This document was prepared by Yong Kim and Geoff Garner.

Revision 5, July 20, 2011

Figure 11-2 – Transport of time-synchronization information

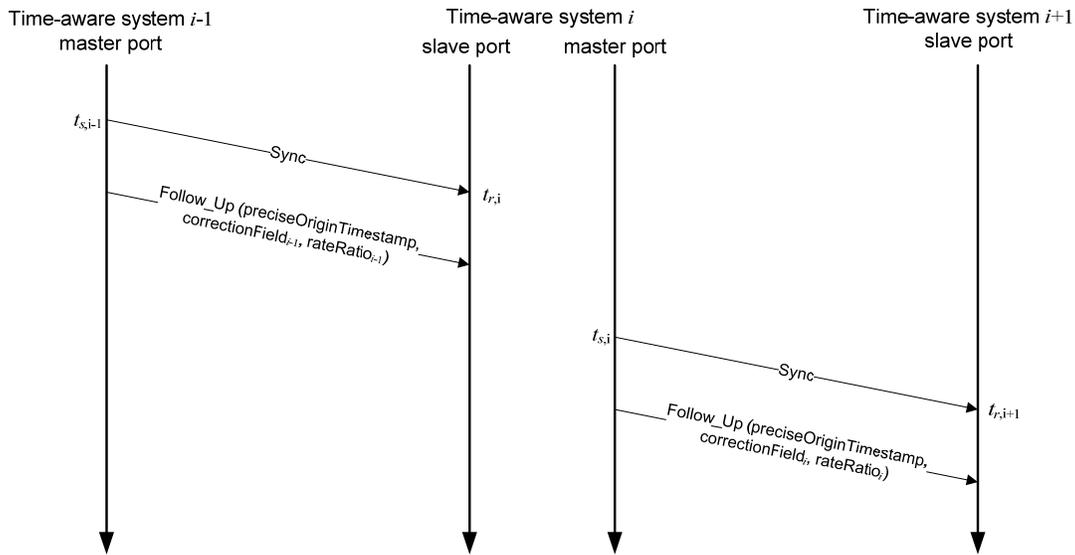
The mean propagation delay on the link between time-aware systems $i-1$ and i , relative to the LocalClock entity of time-aware system $i-1$, is equal to neighborPropDelay (see 10.2.4.7). This must be ~~divided~~ multiplied by rateRatio _{$i-1$} to express it in the grandmaster time base. The total propagation delay is equal to the mean propagation delay plus the quantity delayAsymmetry (see 8.3 and 10.2.4.8); delayAsymmetry is already expressed in the grandmaster time base. The residence time, $t_{s,i}-t_{r,i}$, must be multiplied by rateRatio _{i} to express it in the grandmaster time base.
